0302

Re: **9021 Chicago Avenue-Drainage Memo**
Project No. 61214

Please include project No.
PPR2428

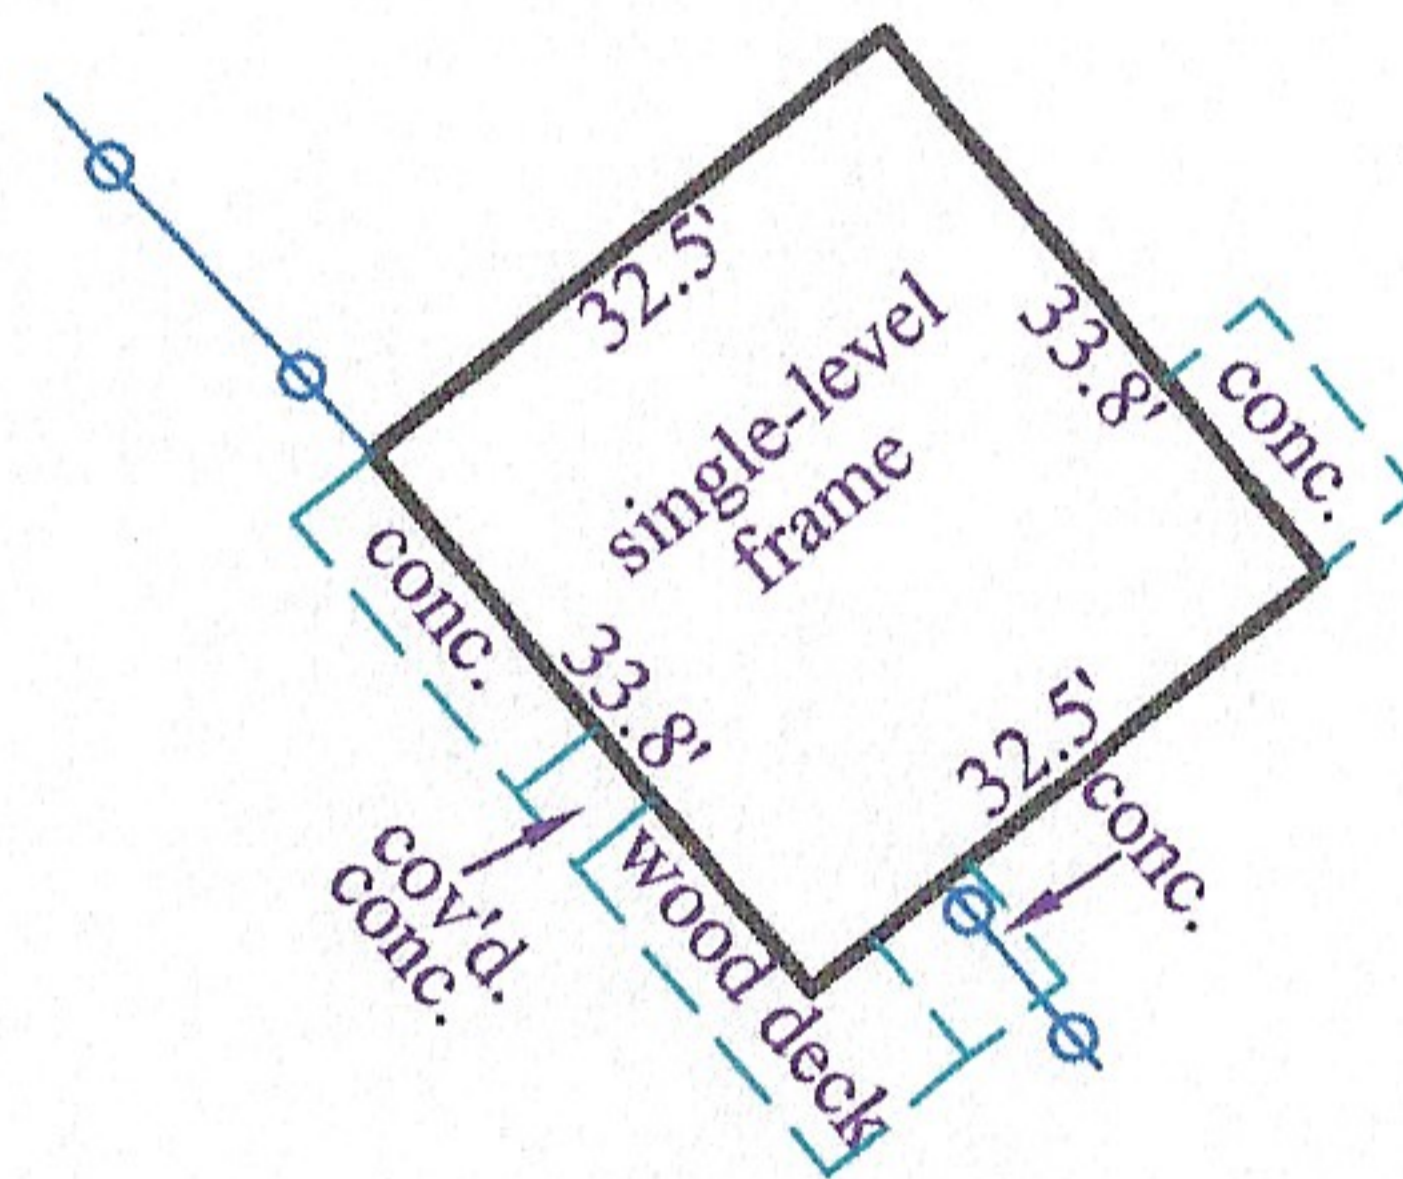
Drainage maps are required to show the direction of stormwater flow for the area before and after the project proposed.
